Huawei PCN AR G3 -20120002 Change Notice of Captive Screws on AR G3 Enterprise Router Filler Panels

PCN No.		AR G3 -20120002	
PCN Version		Rev: 01	
PCN Type		D	
Roadmap	Release date	2012-6-30	
	Implementation date	2012-12-31

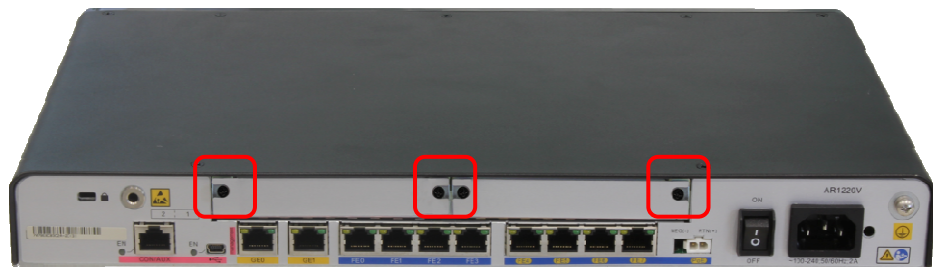
- The following figures show the change of captive screws on AR1200/AR2200/AR3200 filler panels.

- On the AR1220, the captive screws on filler panels of two SIC card slots are changed.

- On the AR2220, the captive screws on filler panels of four SIC card slots and two WSIC card slots are changed.

- On the AR2240, the captive screws on all filler panels of interfaces and the filler panel of one XSIC card slot next to the main control board are changed.

- On the AR3260, the captive screws on all filler panels of interfaces and the filler panels of three XSIC card slots next to the main control board are changed.
